SECTION 009113 – ADDENDUM TWO

- A. Project Name: 21098.01 New Albany Center for Innovation Phase 1
- B. Owner: New Albany Schools, 1112 Wesson Tate Drive, Mississippi 38652
- C. Architect: Dale | Bailey, an Association, One Jackson Place, Suite 250, 188 East Capitol Street, Jackson, MS 39201
- D. Architect Project Number: 21098-01
- E. Date of Addendum Two: 28 February 2023

C-2.0

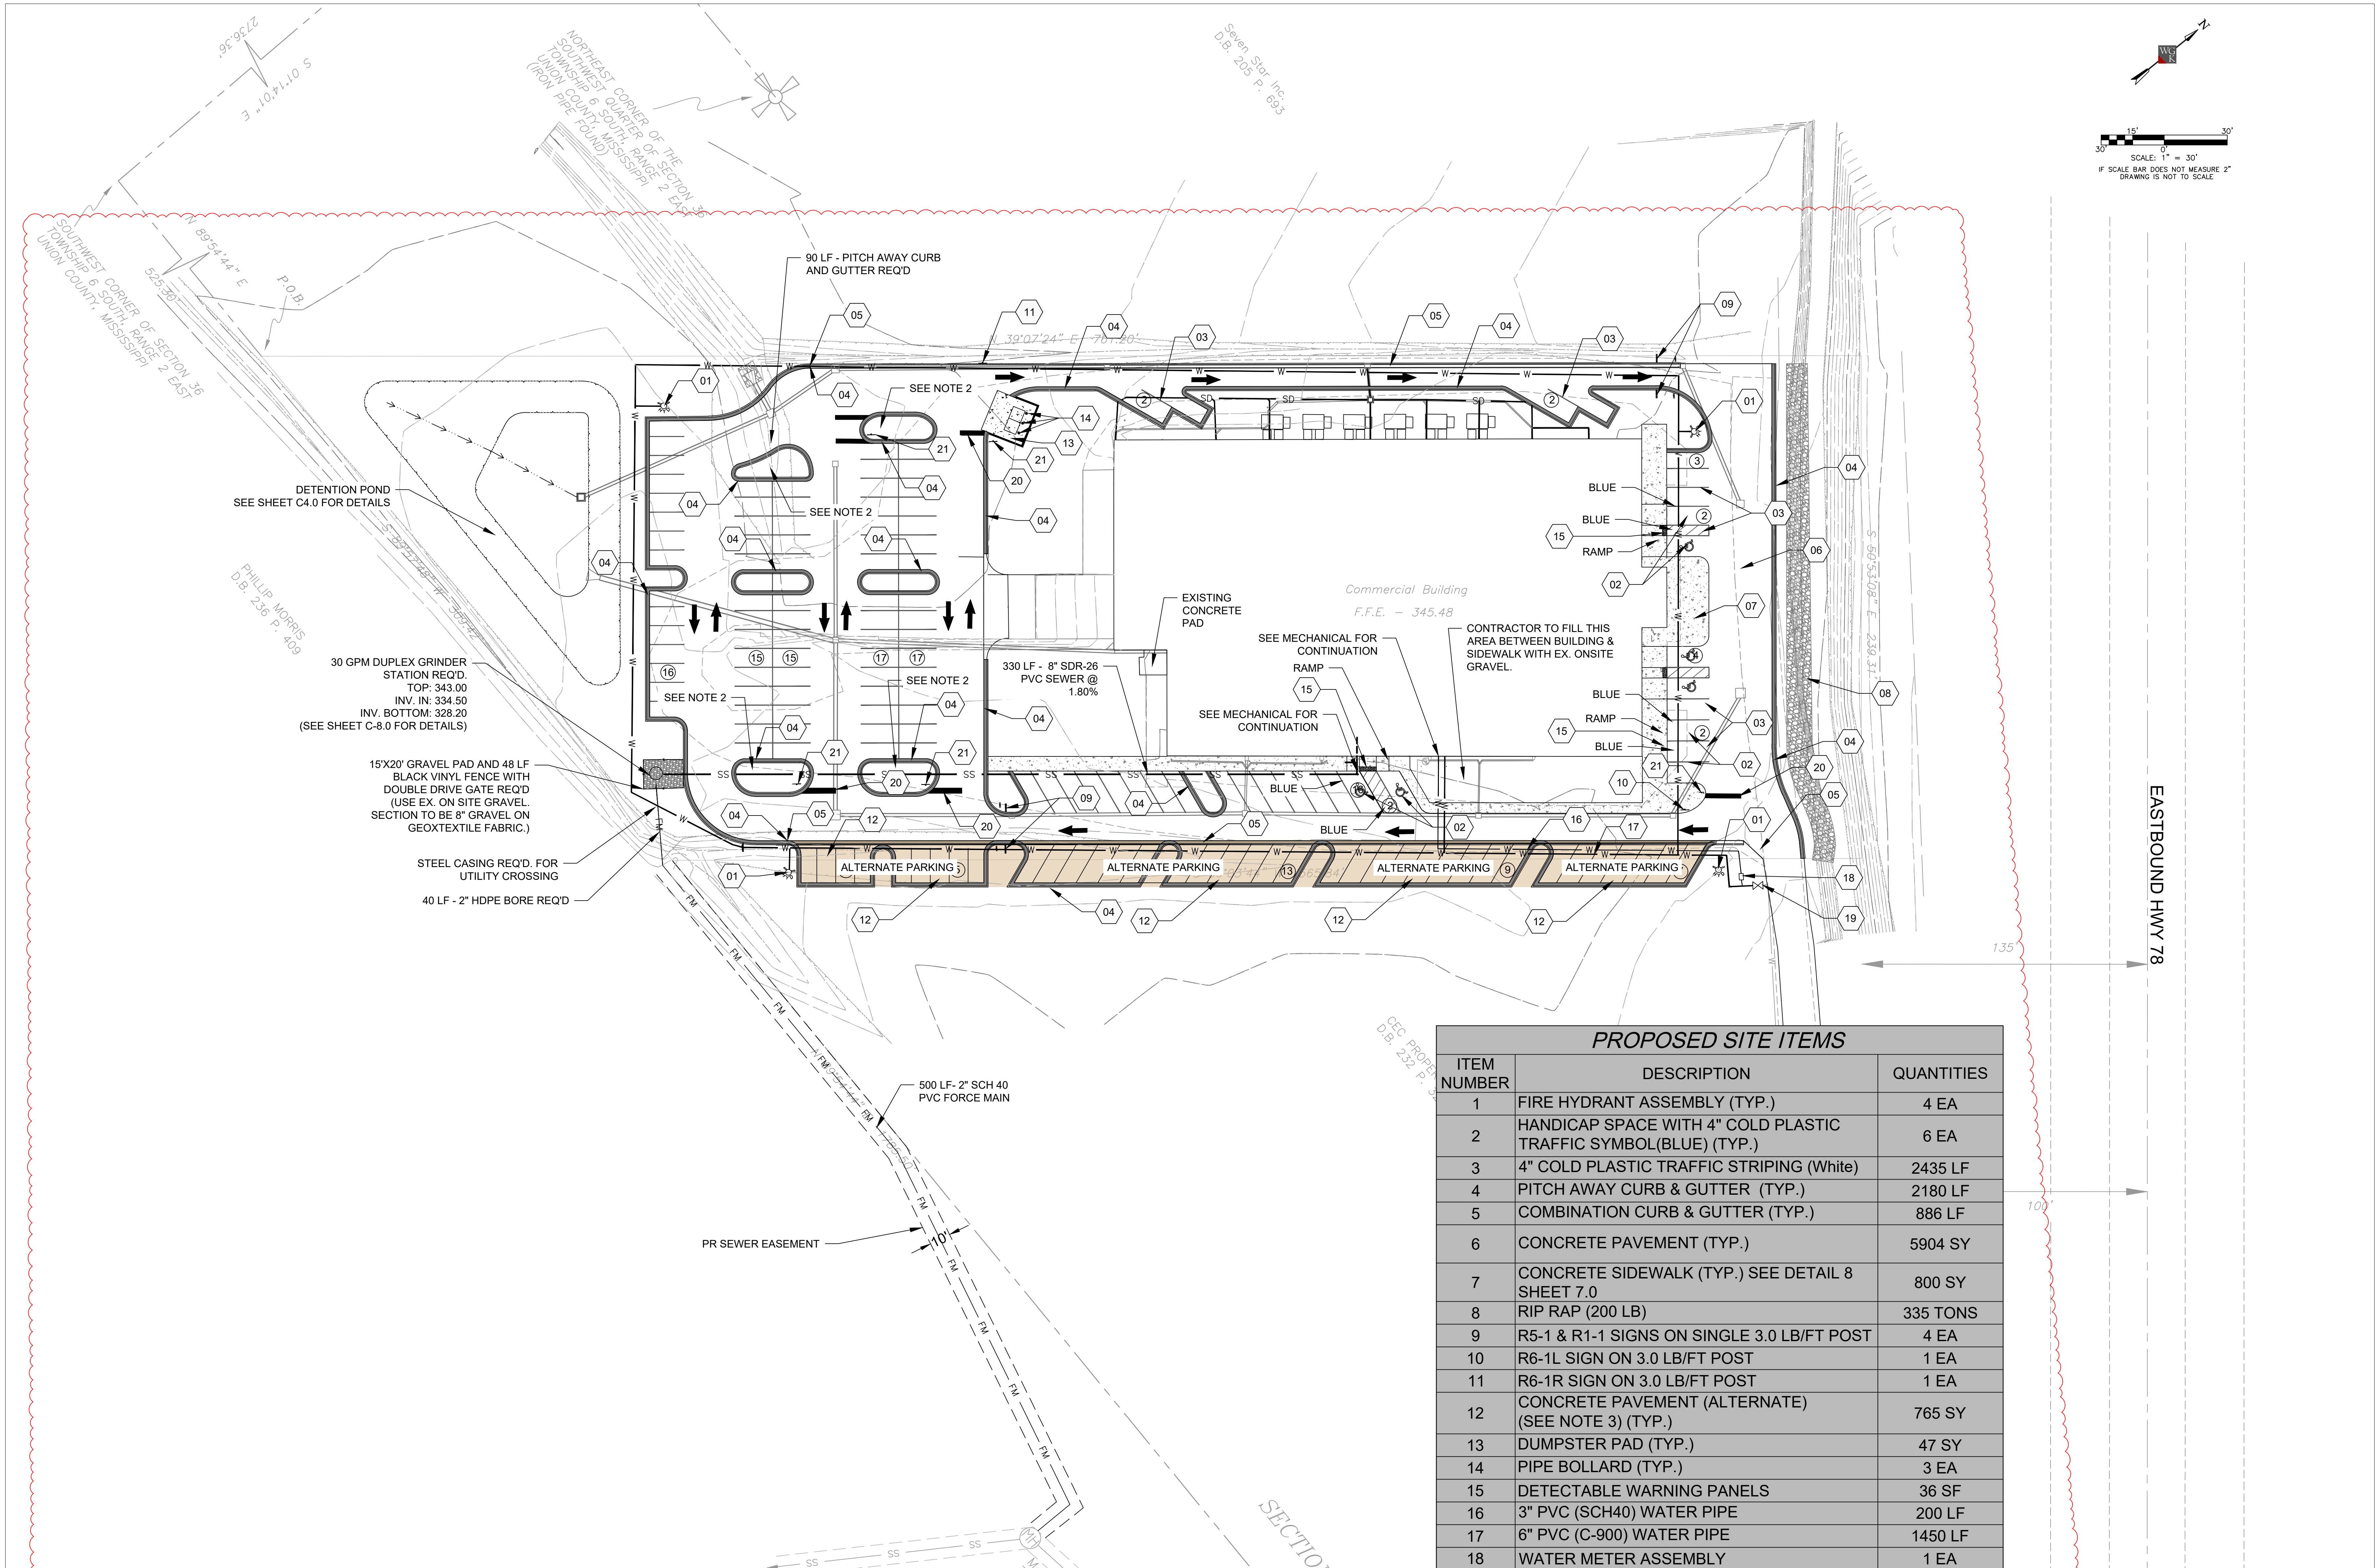
- A. Sheet C1.0 – GENERAL NOTES. Updated Sheet List. See attached.
- B. Sheet C2.0 – DEMO PLAN. Added additional pipe removal items. See attached.
- C. Sheet C3.0 – SITE PLAN. Updated quantities, added additional signage and striping, added additional curbing to meet City's landscape requirements. See attached.

C-4.0

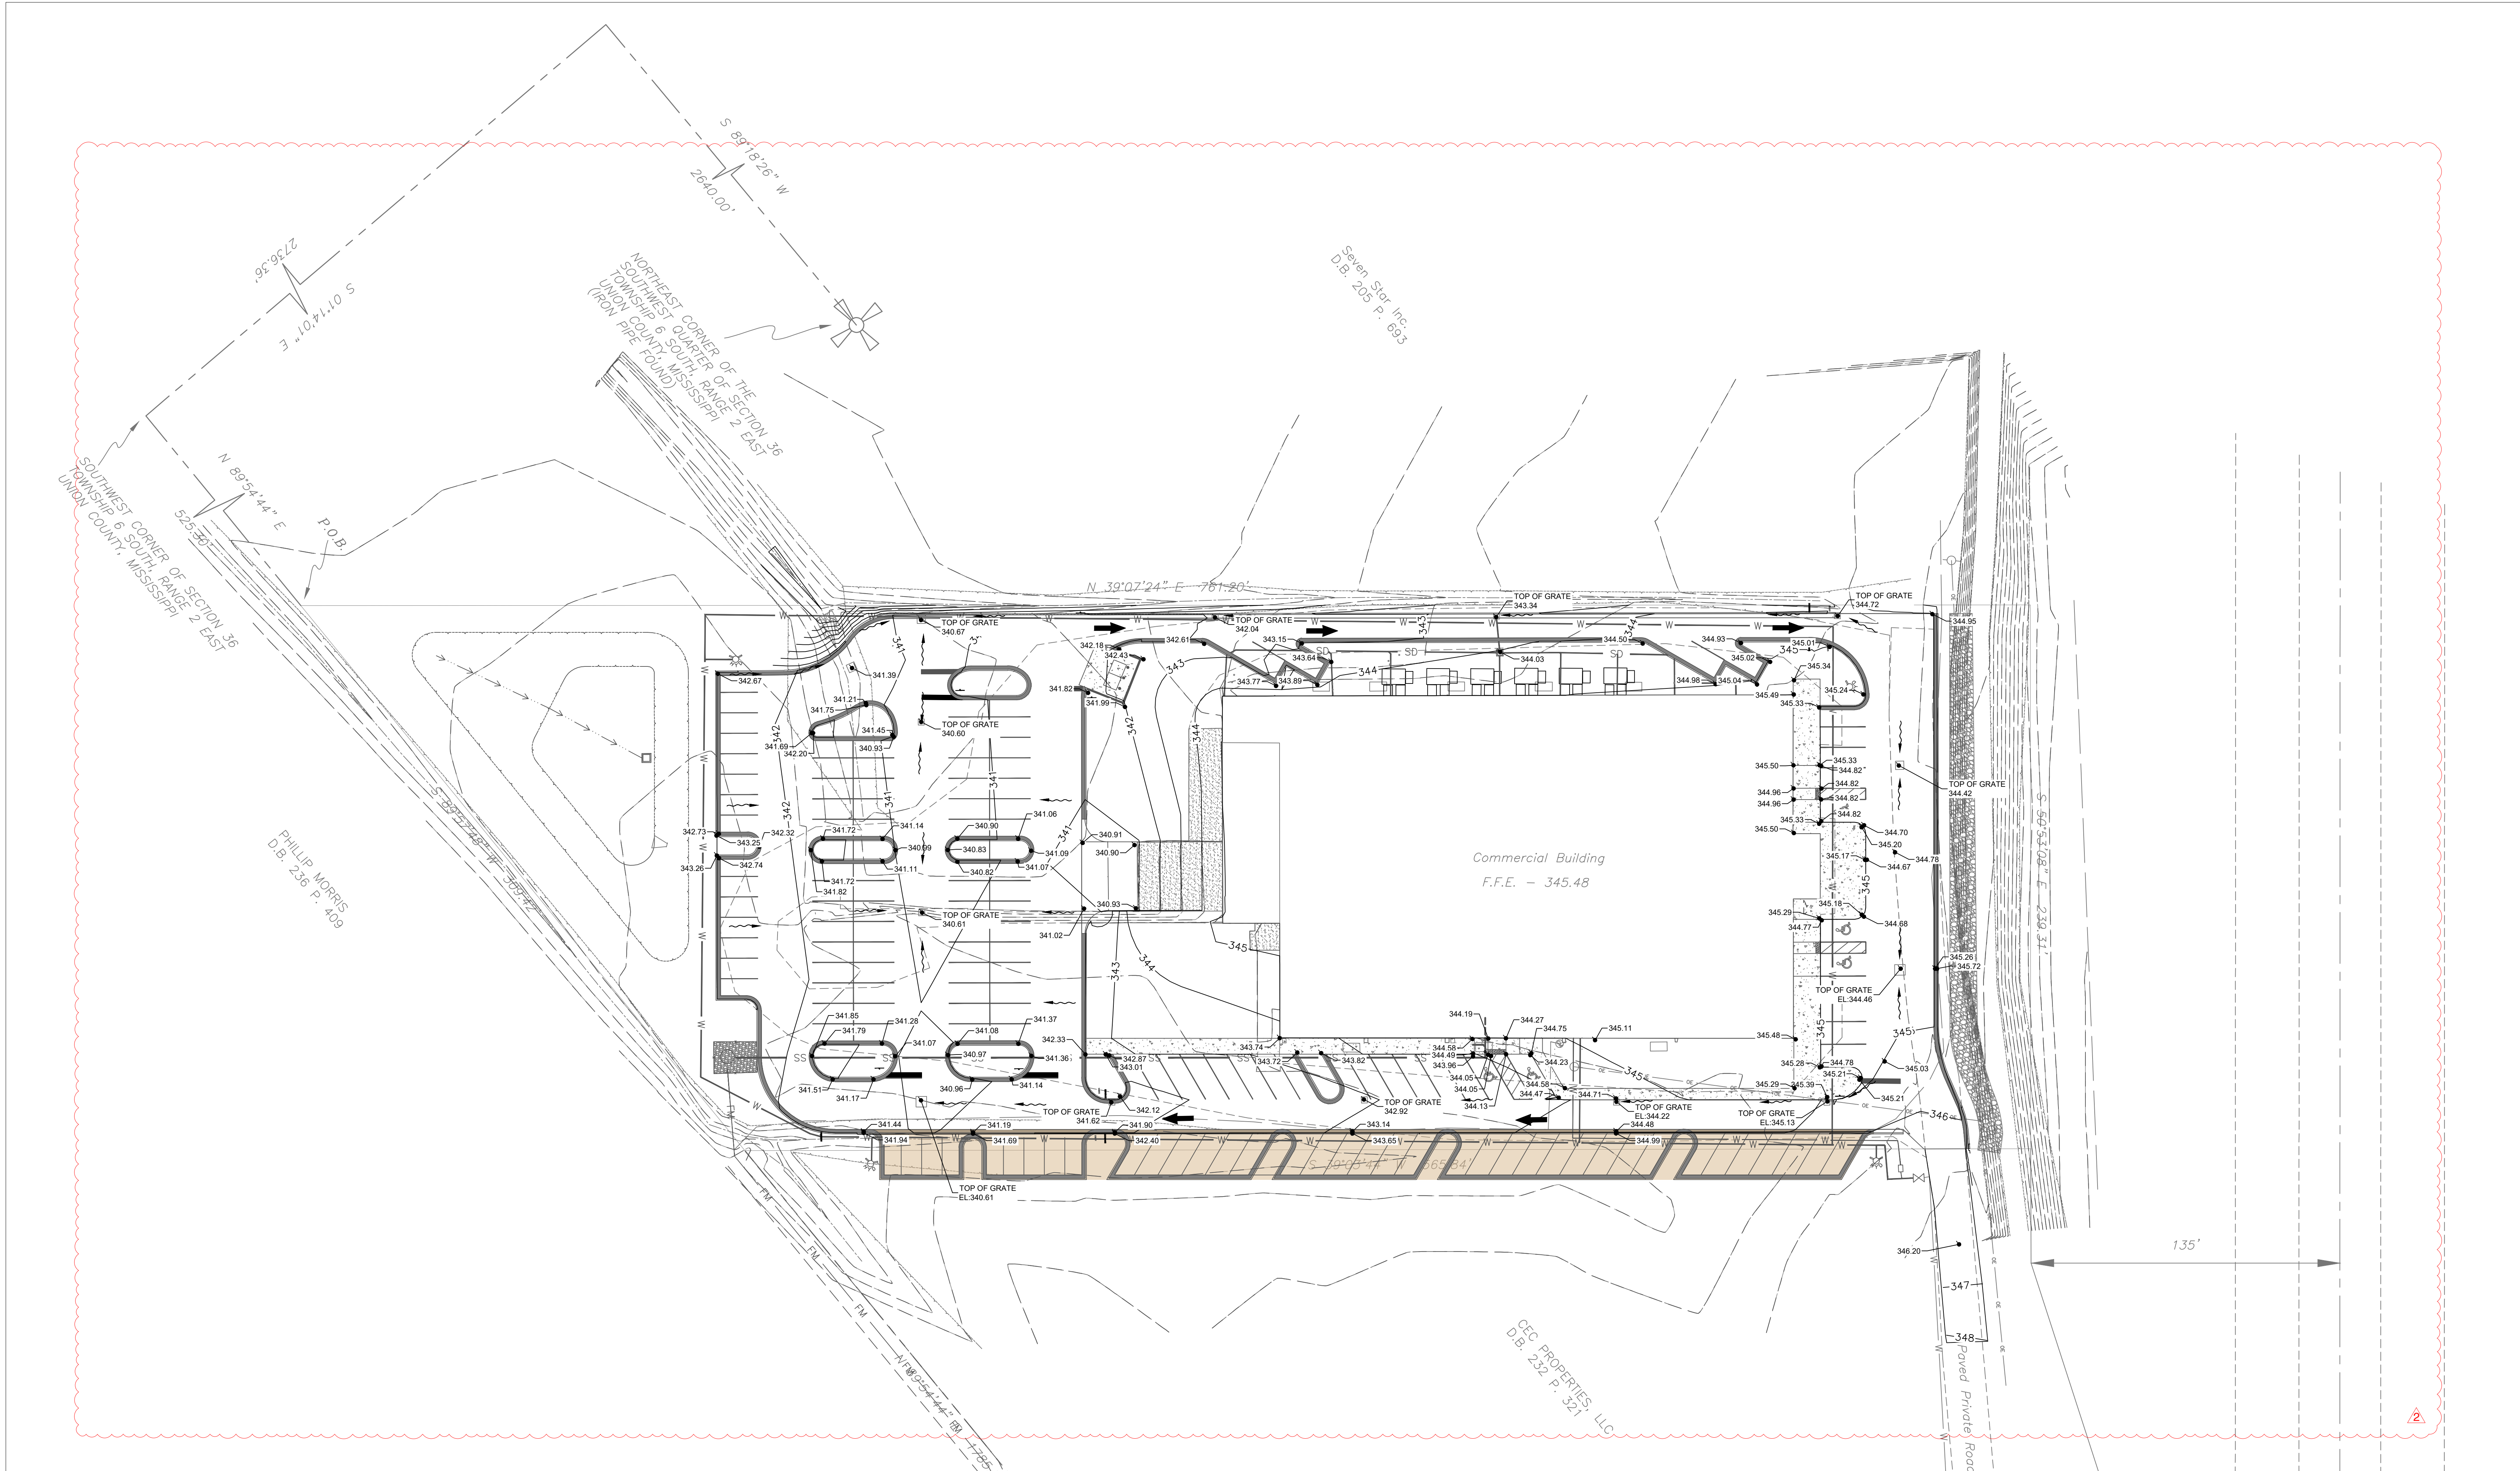
- D. Sheet C4.0 – DRAINAGE PLAN. Added trench drain, updated types of drainage structures to include gutter inlets. See attached.
- E. Sheet C4.1 – GRADING PLAN. Updated grading plan to achieve ADA accessibility. See attached.

C-5.0
GEOMETRIC LAYOUT

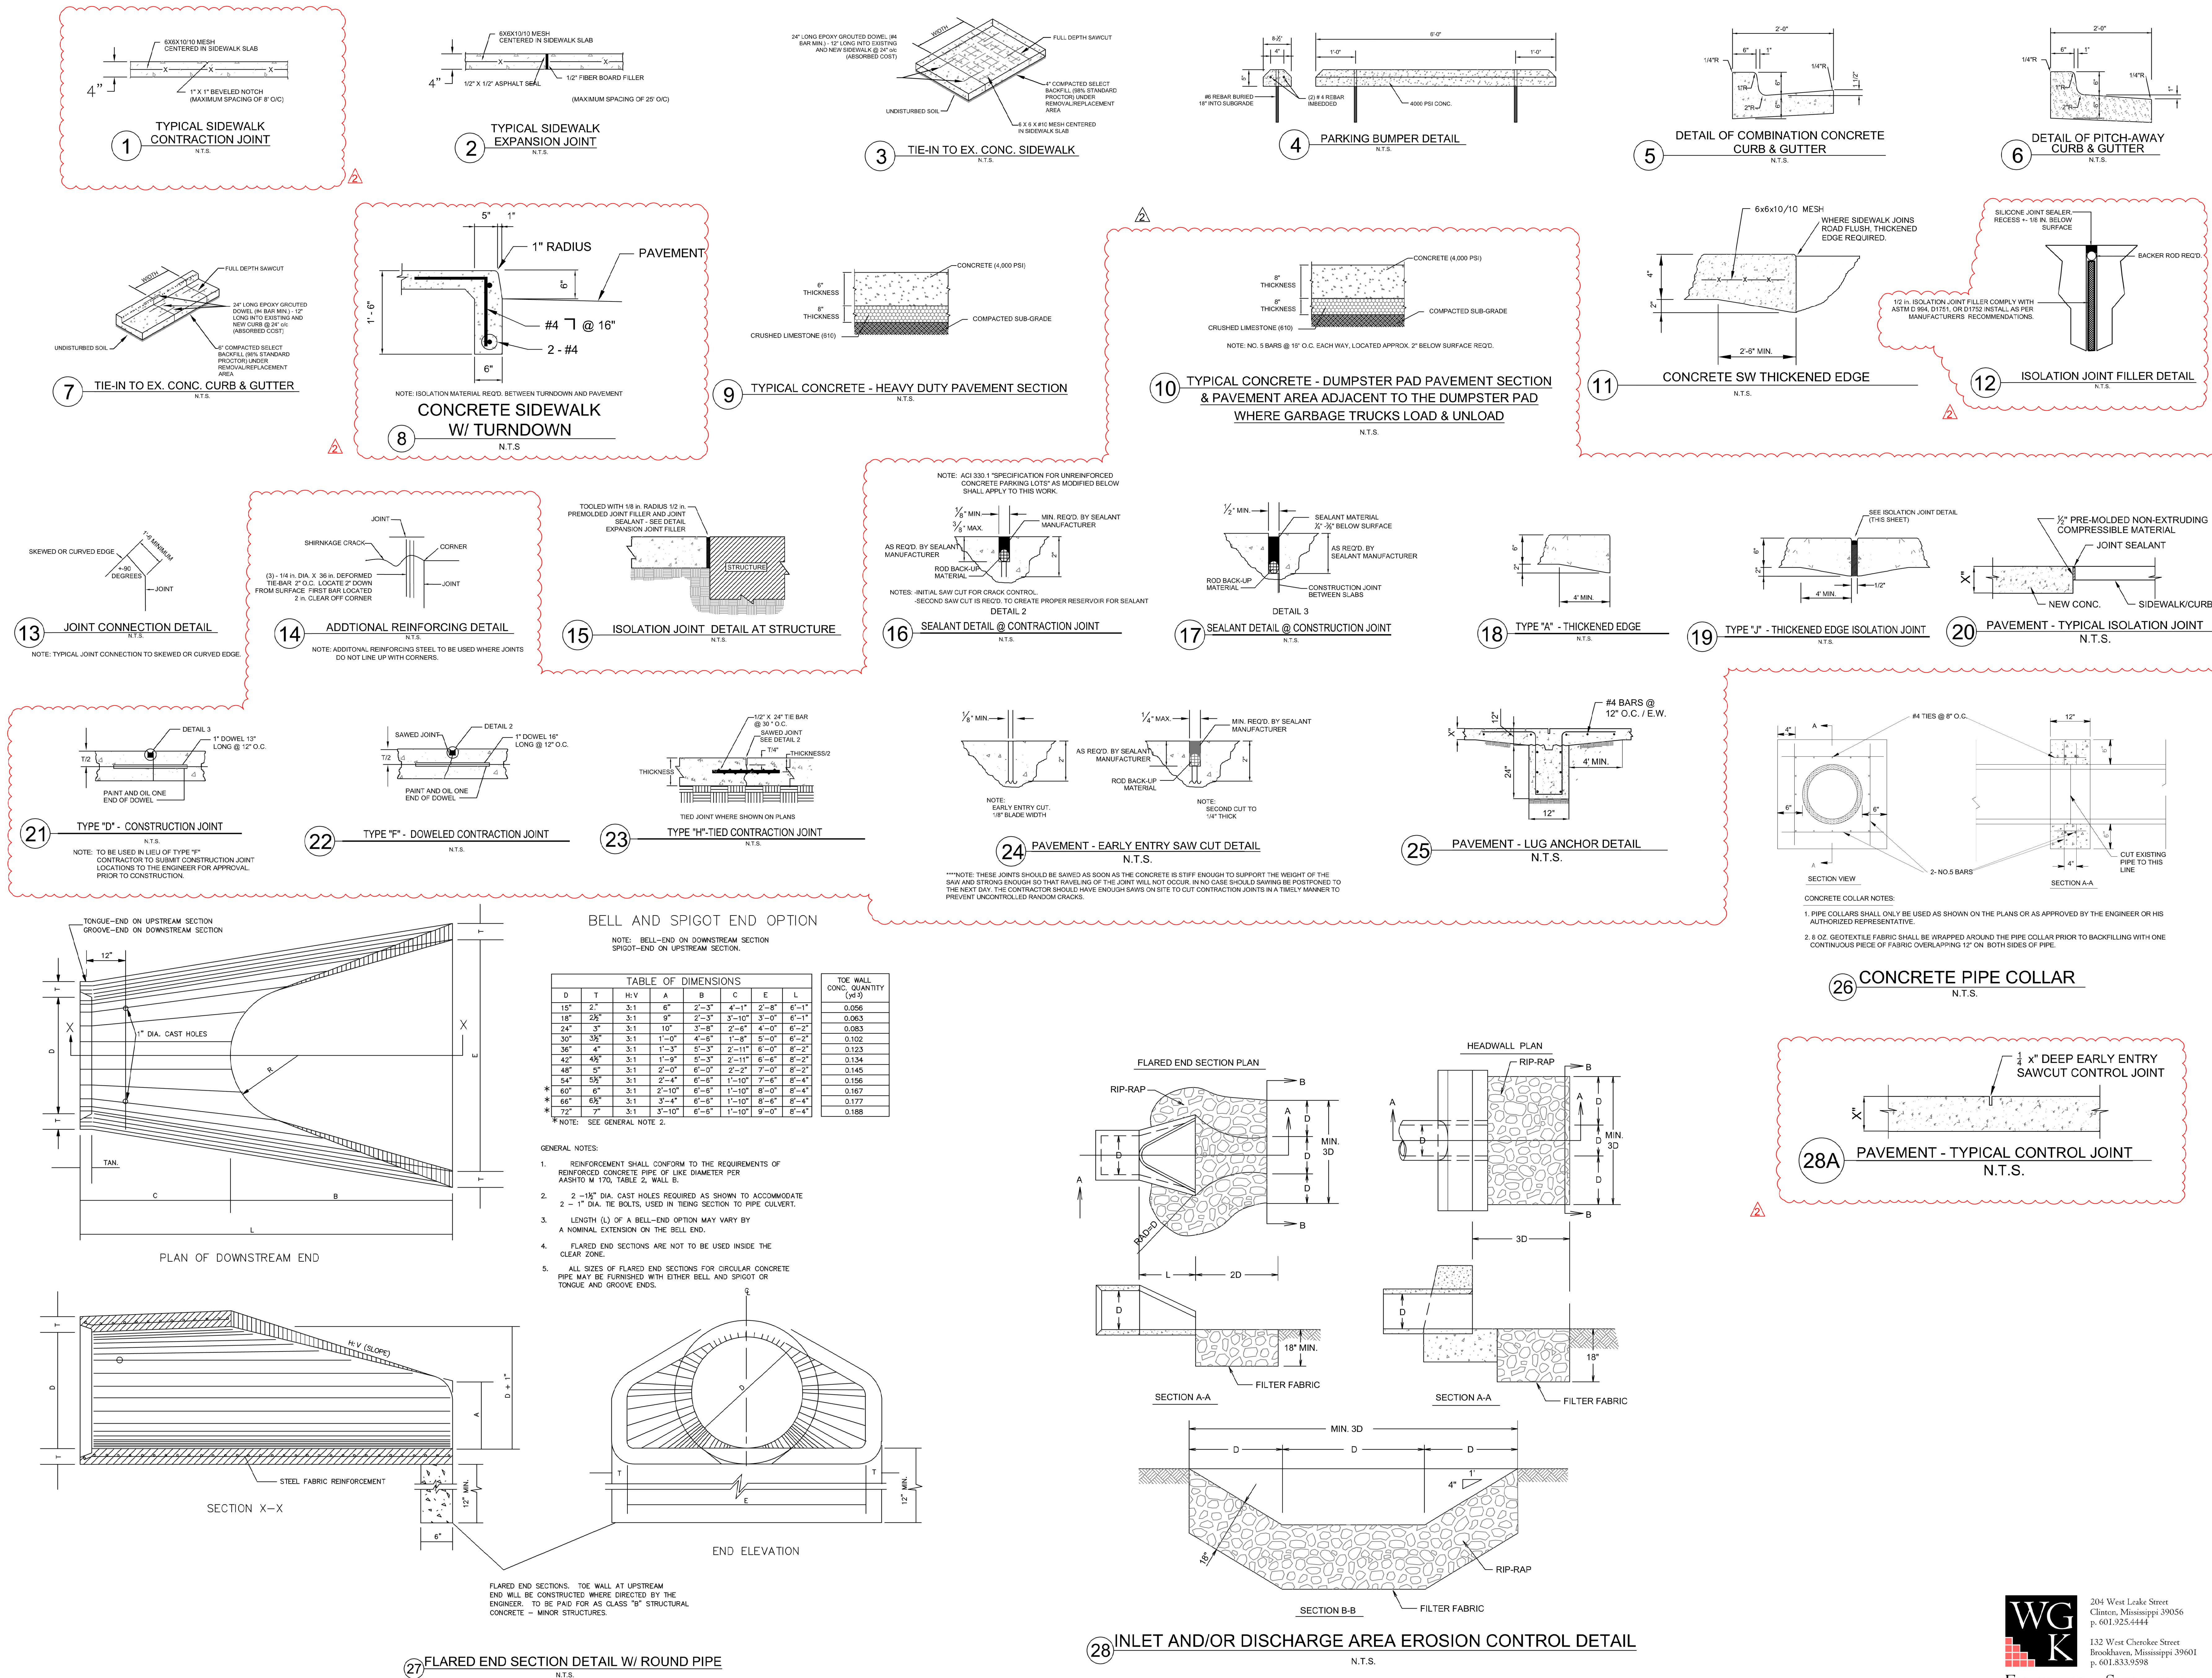
- F. Sheet C5.0 – GEOMETRIC LAYOUT. Added additional dimensions. See attached.
- G. Sheet C6.0 – JOINT LAYOUT. Updated joint layout to match site plan layout, added additional tie-bar and reinforcement panels, included notes about alternate parking. See attached.
